UNITED STATES PATENT AND TRADEMARK OFFICE

APPLICATION NO.	FILING DATE	FIRST NAMED INVENTOR	ATTORNEY DOCKET NO.	CONFIRMATION NO.
10/714,336	11/13/2003	Kenny Chang	JCLA11475	4087
23900	7590	06/16/2006	EXAMINER	
J C PATENTS, INC.			ARENA, ANDREW OWENS	
4 VENTURE, SUITE 250			ART UNIT	
IRVINE, CA 92618			PAPER NUMBER

Office Action Summary	Application No. 10/714,336	Applicant(s) CHANG ET AL.	
	Examiner Andrew O. Arena	Art Unit 2811

DETAILED ACTION

FIG. 6

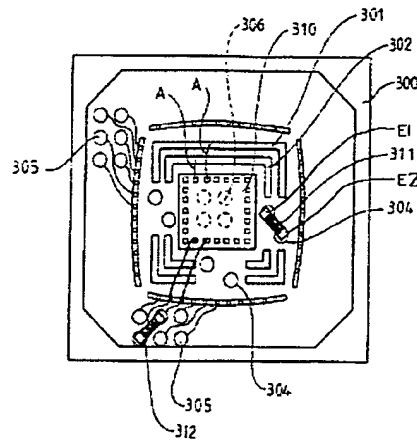
All rejections based on Tao refer to Fig 6, examiner has attached a copy of Tao Fig 6, to which has been added two reference numerals (E1, E2) used for clarity.

Regarding claims 24, 31, and 38, Tao discloses a package substrate (300; col 3 In 41) adapted to carry a die (310; col 3 In 46-48) of a wire bonding type (A; col 3 In 37-38), the package substrate at least comprising:

a substrate (300; col 3 In 41) having a surface, a power pad (301; col 3 In 45-46) and a ground pad (302; col 3 In 46), wherein [, on] the surface of the substrate having a die bonding area, the power pad and the ground pad [are] disposed outside the die bonding area (301 and 302 are outside area 310);

at least one passive component (311; col 3 In 42 - see Fig 5) disposed between the power pad and the ground pad (clear in Fig 6), the passive component having a power electrode (E2) connected to the power pad and a ground electrode (E1) connected to the ground pad (col 3 In 44-46);
